Subject: RE: O8W-PM [redacted] Phase 1,2&3 - Pre-Engineering Meeting

Subject: O8W-PM Meeting [REDACTED] 1101 Phase 1,2&3 - Pre-Engineering

Bucks Creek 1101- PM# [REDACTED] Overview Map

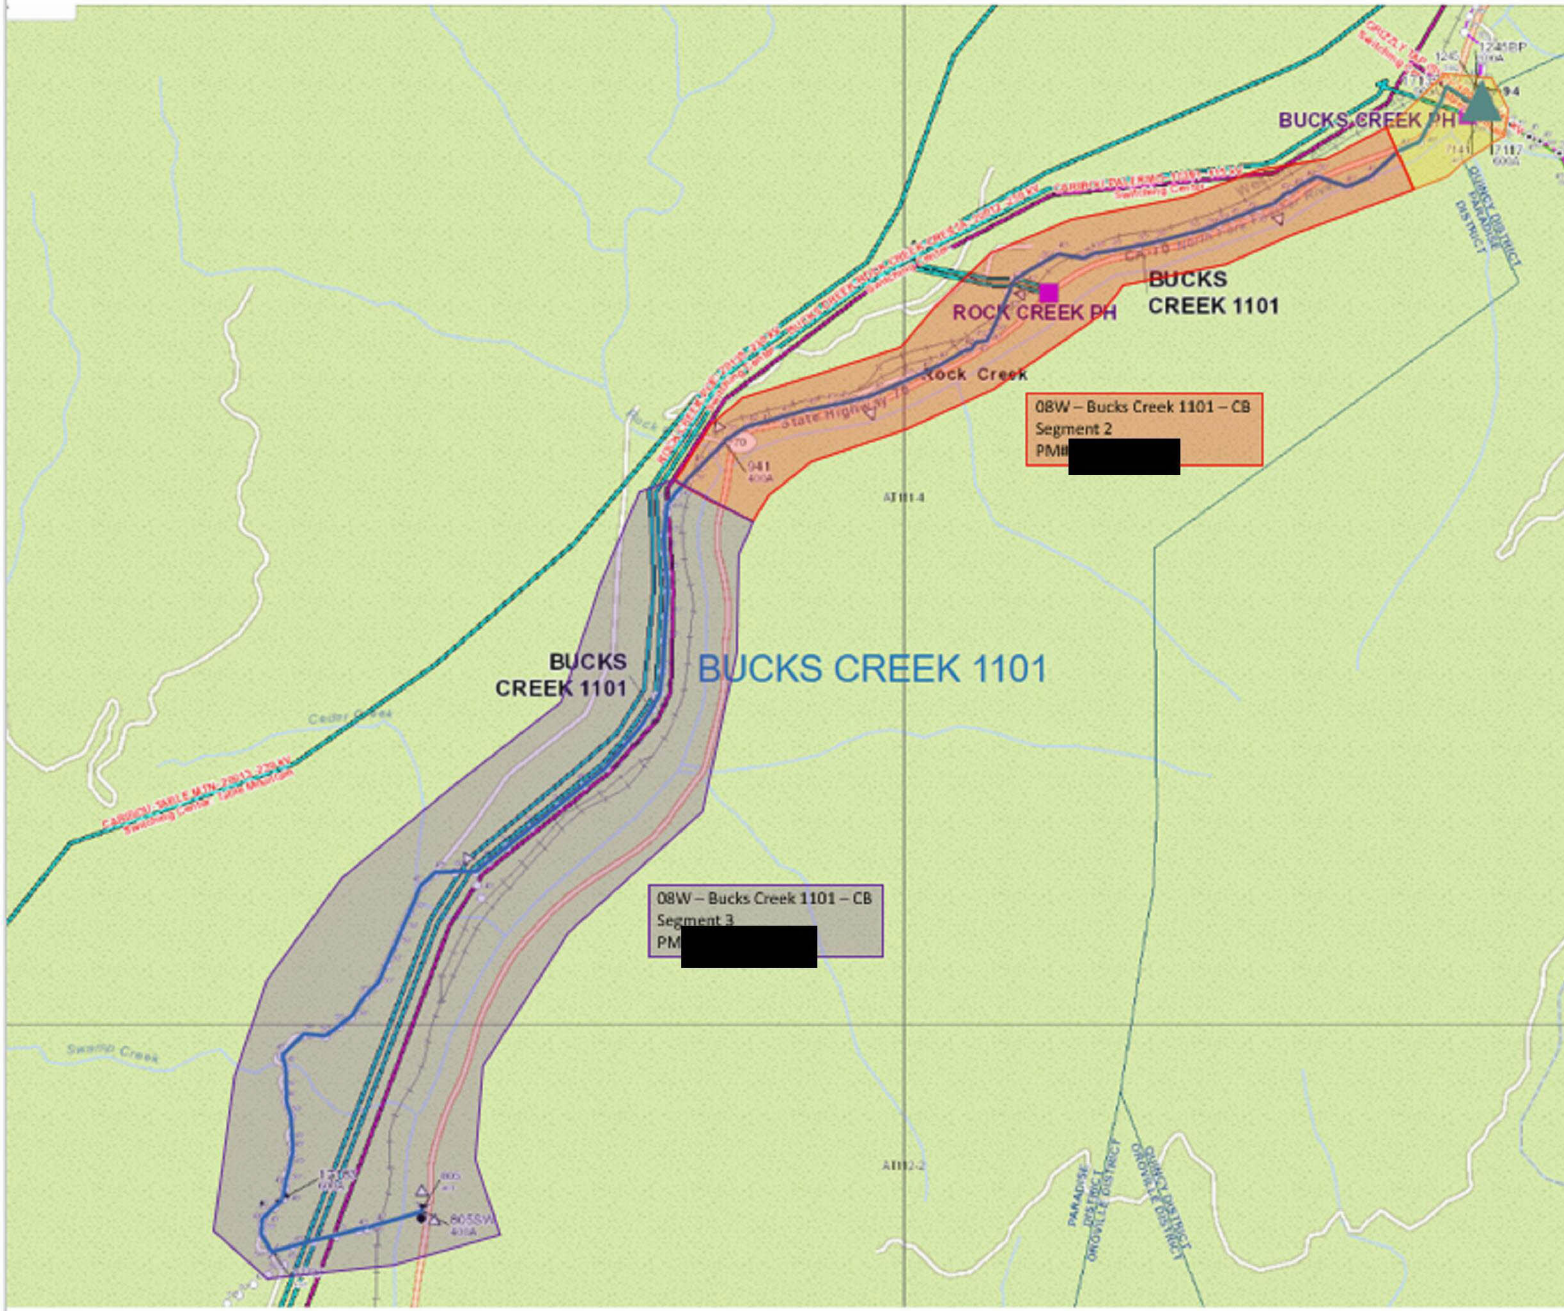
For Bucks Creek there is quite a bit of work surrounding Hwy 70 and we will need a Land Department Base Maps prepared for all 3 Orders. This will delay the EOD dates until these can be developed and provided to the Vendor... We will also need answers to the questions outlined by [redacted] below...
